AMENDMENTS TO THE DRAWINGS:

REMARKS

FIG. 1

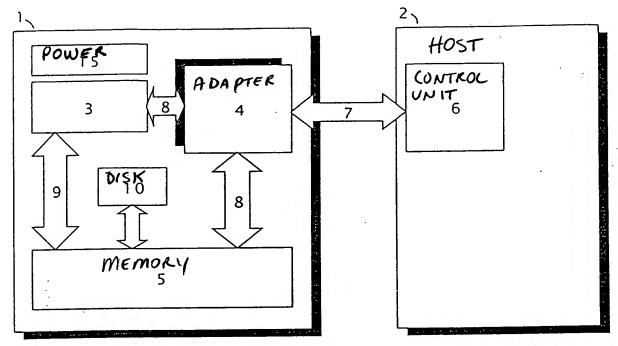
In numbered paragraph 1 on page 2 of the Office Action, the drawings are objected to because the reference character "8" has been used twice. As recognized by the Examiner, the reference numeral "8" has been used to designate the same PCI bus at two different locations such that correction to the drawings is unnecessary.

In numbered paragraph 2, Figures 1 and 2 are objected to as failing to contain suitable legends. Accordingly, submitted herewith is a corrected drawing along with a replacement sheet. Withdrawal of the objections to the drawings is therefore requested. The proposed changes to the Figures also obviate the objections raised in numbered paragraph 3 on page 3 of the Office Action.

Figures 1 and 2 have been amended to include legends.
